SERVICE DIRECTIVE BULLETIN NO. 0118

Revision 1

1. SUBJECT: Idler Yoke Inspection, P/N 28-13299-3 (Machined Component)
2. MODEL: F-28A, 280, F-28C, 280C, F-28F, 280F, and 280FX
3. EFFECTIVITY: All S/N excluding F-28F S/N 831 and subsequent and 280FX S/N 2146 and subsequent.
4. BACKGROUND:

Figure 1 – Idler Yoke, P/N 28-13299-3

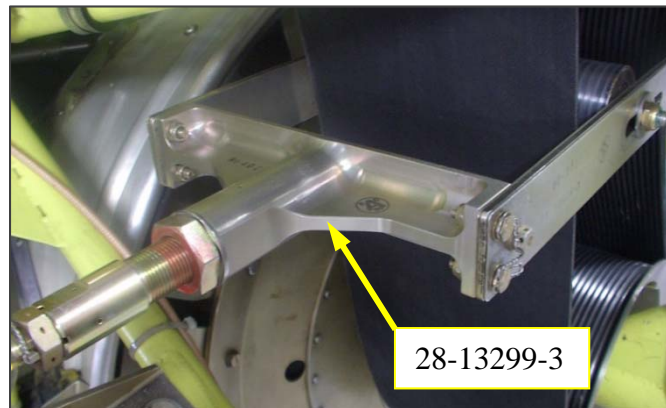
- 6.1 Inspect for cracks (reference Figure 1 and Figure 2) using dye penetrant method. Follow the dye penetrant manufacturer's instructions.

6.1.1 A heavy, solid line bleed-back indicates a crack. Reject the idler yoke and replace with an airworthy idler yoke, P/N 28-13299-3.

6.1.2 If no bleed-back indications are present, the inspection is satisfactory. Thoroughly clean the idler yoke per the penetrant kit instructions.
